HIGHWAY CONSULTEE COMMENT RESPONSE

LHA Ref: ET/DC/MZ/P/2024/1554 (dated 18.03.25)

Planning Application REF: P/2024/1554

Address: Hydro Aluminium Deeside Ltd, Bridge Road, Wrexham Industrial Estate, Wrexham, Ll13 9ps

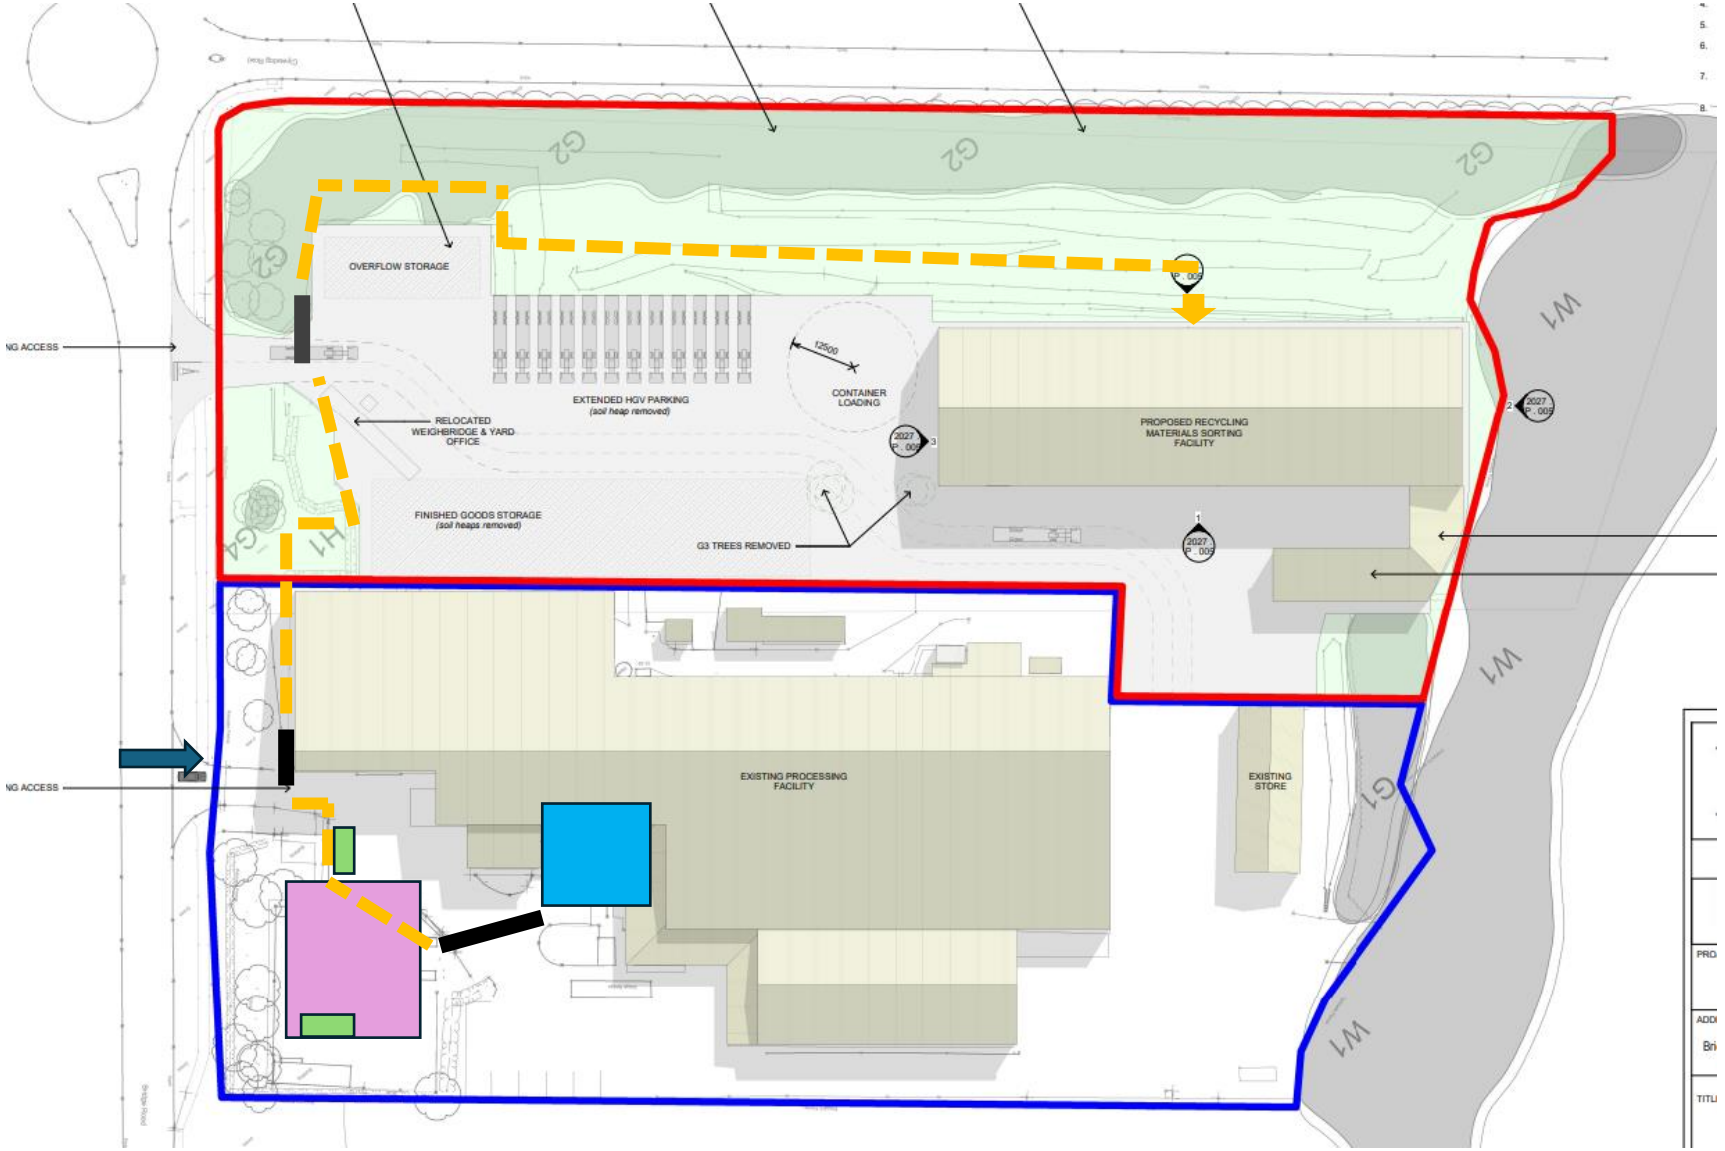
Car, cycle & pedestrian routes within the site.

All employees will use the southern gate to access parking and cycle stores. A marked segregated pedestrian route will be used to access all areas of the site.

Pedestrian routes are tightly controlled within the site and final routes will be subject to detailed design by the health and safety departments within the organisation post approval. However, the route shown on the above sketch will likely be implemented.
